File: RZ 16-754653

Re: Application by 1008358 BC Ltd for Rezoning at 10451/10453 No. 1 Road from
Single Detached (RS1/E) to Coach Houses (RCH1)

Staff Report

TREE SURVEY

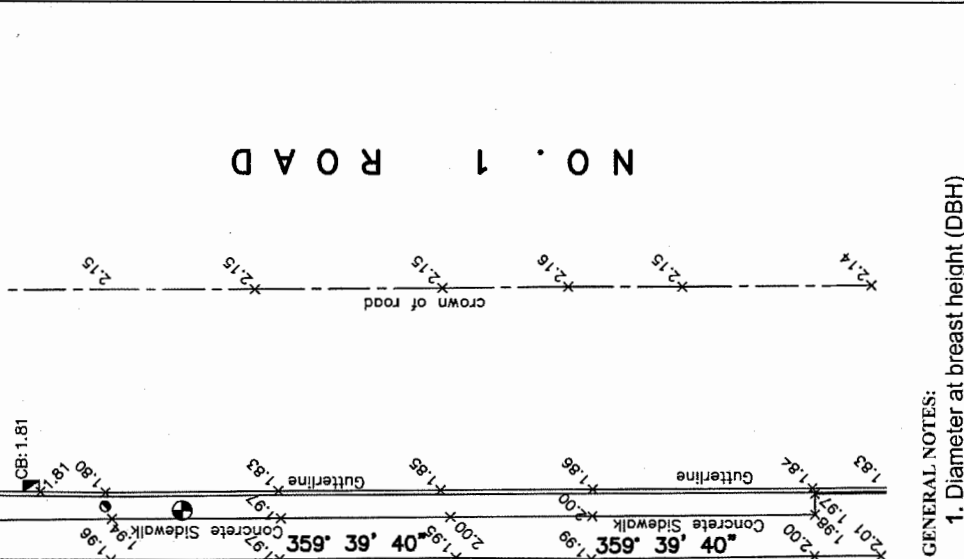
- One tree (#22) located on the adjacent neighbouring property is identified as a 46 cm conifer in excellent condition. The neighbouring tree should be retained and protected per the City of Richmond Tree Protection Information Bulletin Tree-03. Tree protection fencing should be located a minimum of 2 m onto the development site, to a total of 3 m wide on either side of the tree. In addition, any proposed building permit application should illustrate a setback of 0.6 m outside the 2 m minimum tree protection zone for any new building. A Tree Protection Plan is provided in Attachment 6.
- As there are no trees located on site, a minimum of two new trees should be planted on each lot as a condition of rezoning approval.

Tree #22 on the neighbouring property is to be retained and protected. The applicant has submitted a tree protection plan showing the tree to be retained and the measures taken to protect it during the development stage (Attachment 6). To ensure that the tree identified for retention is protected at development stage, the applicant is required to complete the following items:

- Prior to final adoption of the rezoning bylaw, submission to the City of a contract with a Certified Arborist for the supervision of all works conducted within or in close proximity to the tree protection zone. The contract must include the scope of work required, the number of proposed monitoring inspections at specified stages of construction, any special measures required to ensure tree protection, and a provision for the arborist to submit a post-construction impact assessment to the City for review.
- Prior to demolition of the existing dwelling on the subject site, installation of tree protection fencing around Tree #22. Tree protection fencing must be installed to City standard in accordance with the City's Tree Protection Information Bulletin Tree-03 prior to any works being conducted on-site, and remain in place until construction and landscaping on-site is completed.
